TEXAS UTILITIES ELECTRIC COMPANY
COMANCHE PEAK STEAM ELECTRIC STATION, UNIT 1
DOCKET NO. 50-445
AMENDMENT TO FACILITY OPERATING LICENSE

Amendment No. 52
License No. NPF-87

ATTACHMENT TO LICENSE AMENDMENT NOS. 32 AND 38

Replace the following pages of the Appendix A Technical Specifications with the attached pages. The revised pages are identified by Amendment number and contain marginal lines indicating the areas of change. The corresponding overleaf pages are also provided to maintain document completeness.

FIGURE 2.1-1a

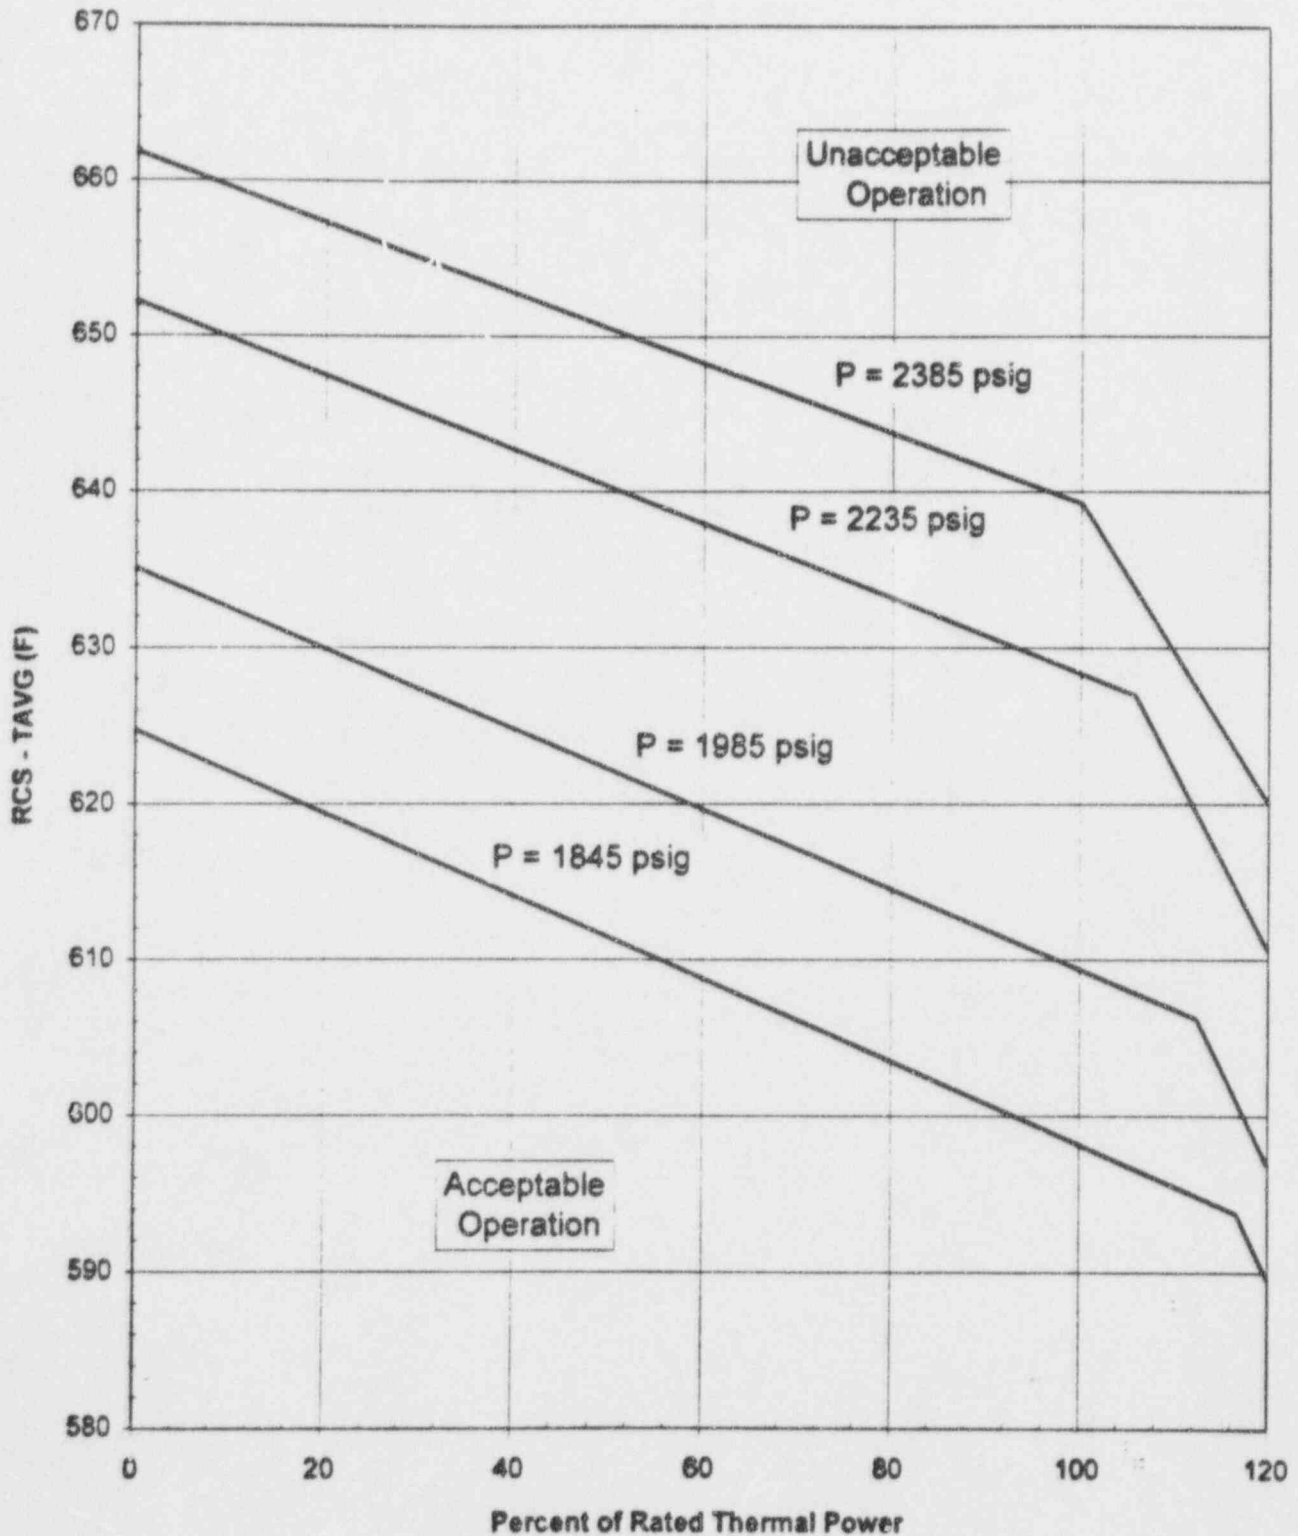
2.1.1 The combination of THERMAL POWER, pressurizer pressure, and the highest operating loop coolant temperature (T_{avg}) shall not exceed the limits shown in Figure 2.1-1.
